Remarks

Version With Markings To Show Changes Made

FIG. 3

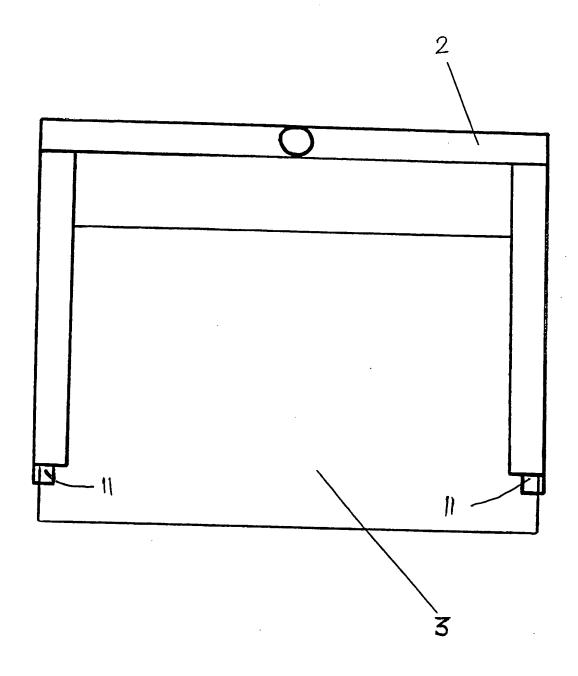
Regarding numbered paragraph 3 of the office action, since the spring of claim 15 was not shown as such in the drawings, claim 15 has been deleted. However, the grooves are shown in the drawings, and claim 17 has been retained. The specification has been amended above to identify the grooves with the reference numeral 11, and the proposed drawing change specifically refers to the grooves as illustrated, already, in the drawings. Approval is therefore requested, and no new matter is introduced since the grooves are already shown in the drawing figures.

With reference to Figure 3, a preferred support, i.e. a fork, comprises two tines provided with facing grooves <u>11</u>. A tray 3 carrying a culinary preparation is inserted in the grooves <u>11</u> which also serve to hold it. In addition, the forks are adjustable so that they can accommodate trays of different sizes.
